LOCAL MEMBER CONCERNS

APPLICATION No. **19/02864/MNR** APPLICATION DATE: 07/11/2019

LOCATION: REAR OF 17 AEL-Y-BRYN, RADYR, CARDIFF, CF15 8AZ

PROPOSAL: ERECTION OF DWELLING (AMENDMENTS TO DESIGN OF DWELLING GRANTED PERMISSION UNDER REF 12/02142/DCO) AND GARAGE

Doc.G.001a

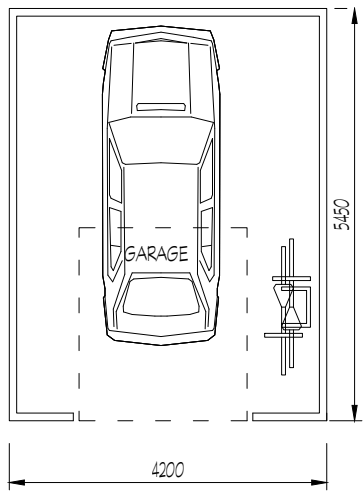
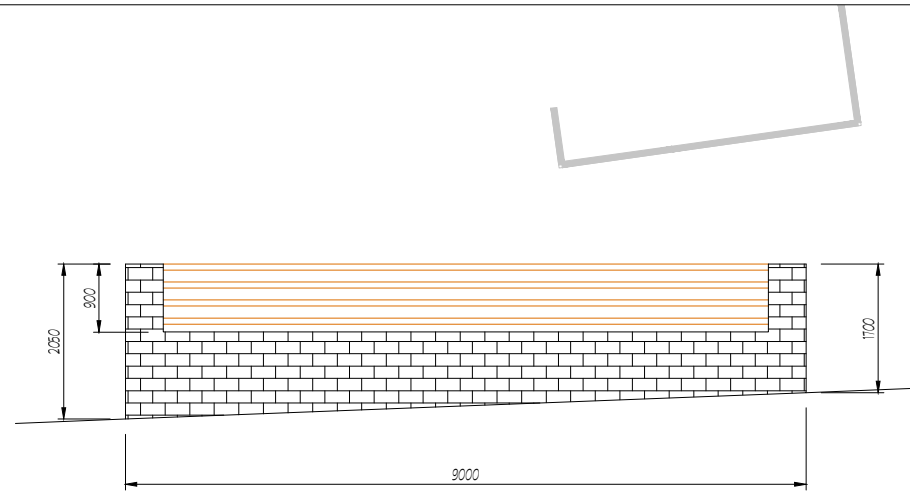
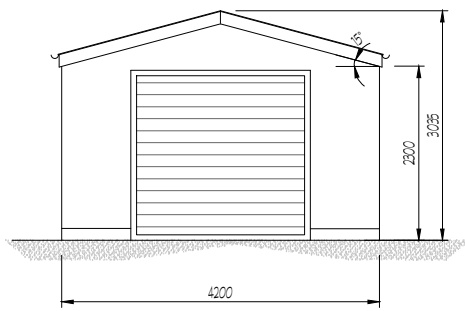
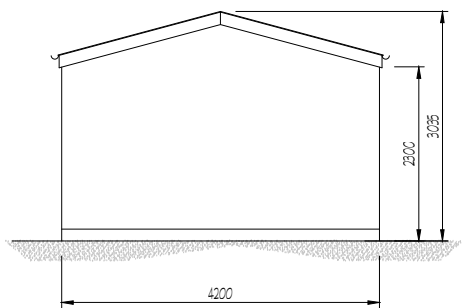
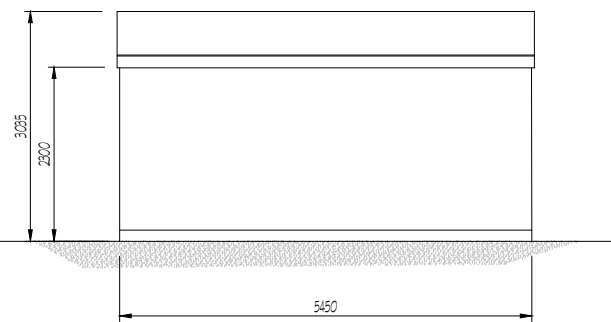
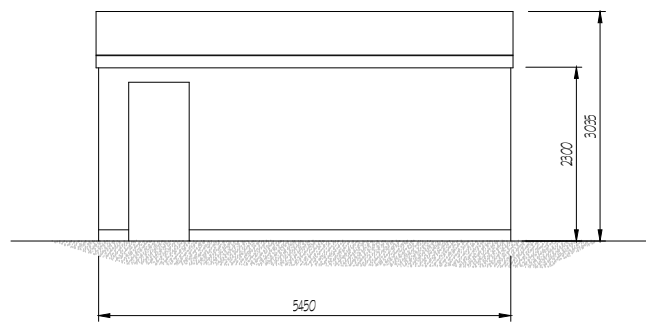
7. The existing vehicular access and hardstand at the front of the dwellinghouse, as depicted on drawings DOC.G.001A and DOC.R.001 Rev B, shall be permanently removed and replaced with a boundary structure and soft landscaping in accordance with details and a timetable for compliance which shall have been submitted to and approved in writing by the local planning authority within one month of the date of this notice.

- a detached garage measuring 2.2m x 5.45m with a pitched roof to a height of 3m has been built on land adjacent to the house that was not included in the original planning permission. The garage has been constructed on top of a retaining wall and a level patio area has been formed between the garage and the side of the house, which is approximately 7.5m away. A 1.7m to 2m high wall/fence has been erected on the boundary with the highway in front of this patio;

- 11) Inadequate car parking facilities.
A car cannot be parked on the front as this area is too small and restricted by a wall, steps etc. and the garage is not up to standard as no turning area is provided so that cars can enter and leave in a forward gear. The garage should be repositioned for manoeuvrability for vehicles, and away from the boundary line that makes the wall over 6m high, or replaced with a more modest cycle store.

Reason: Use of this area for the parking of vehicles is not possible without illegally crossing the footway and the parking space and access should therefore be replaced with an appropriate boundary structure and soft landscaping, in the interests of visual amenity and biodiversity enhancement, to mitigate against the effects of climate change and

- 8.16 11) Inadequate car parking facilities.
The adopted Supplementary Planning Guidance 'Managing Transportation Impacts (Incorporating Parking Standards)' does not require any car parking facilities to be provided for a development of this nature, therefore it is acceptable if the area to the front of the house is too small to park a car. This area is in fact unsuitable for parking as the Highways Authority has refused to allow a crossover to be constructed in this location. The garage that has been built is of acceptable dimensions to accommodate one vehicle, which accords with the maximum standard set out in the SPG, and its position is acceptable to the Highways Authority in terms of the manoeuvring of vehicles onto and off of the highway. The crossover providing access to the garage has been approved by Highways officers.
